# CUBEX LTD. PRODUCT UPDATE

BULLETIN: PU-0017

SUBJECT: HEAT EXCHANGER CP70015

5200 DRILL HEAT EXCHANGER RETROFIT AIR SCHEMATIC

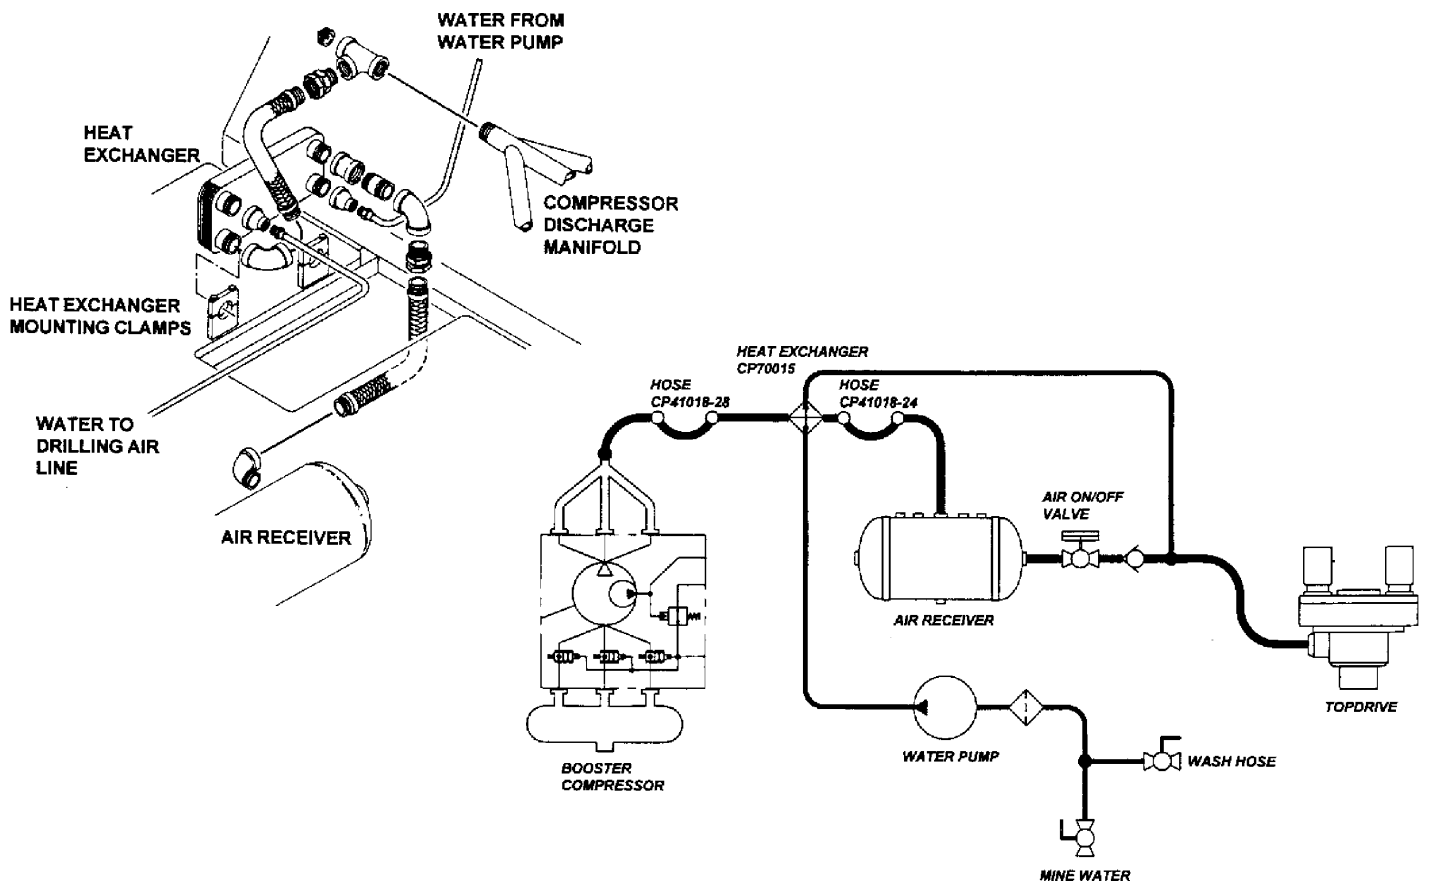
**INFORMATION:** This new Heat Exchanger (CP70015) will increase the life of components downstream by reducing the compressor discharge air temperature. Affected components include top drive seals, the hammer and the drill string, which will all benefit by lasting longer. Installation diagrams for this update follow:
